CITY COUNCIL SPECIAL CALLED MEETING

March 2, 2021 at 8:00 p.m.

From: Wesley Parker <wesley@parker-engineering.com>
Sent: Thursday, February 11, 2021 5:51 PM
To: Bill Sawyer
Subject: Guardrail options
Attachments: PE20178_Number_8_options.pdf

Griffin Road
Guardrails
3 Options

Option 1

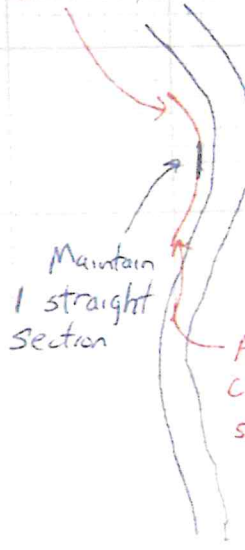
Option #1 – Add one 12.5 feet long straight section to the existing section. Cost \$2700

Option #1 is the least expensive and would accomplish the goal but it would not look correct. Plus the price is almost the same as Option #2 – Option #1 is not worth considering. The Contractor stated that the prices are roughly the same due to the cost of shipping. Option #2 would look a lot better. Councilman Lee asked if we should place one on the east side of the road. That side isn't as critical, but you would have that extra section that would not be doing any good in storage. I recommend Option #3, but if the budget is a concern, then Option #2.

Add
1 straight
section
Maintain
2 straight
sections,

\$2100
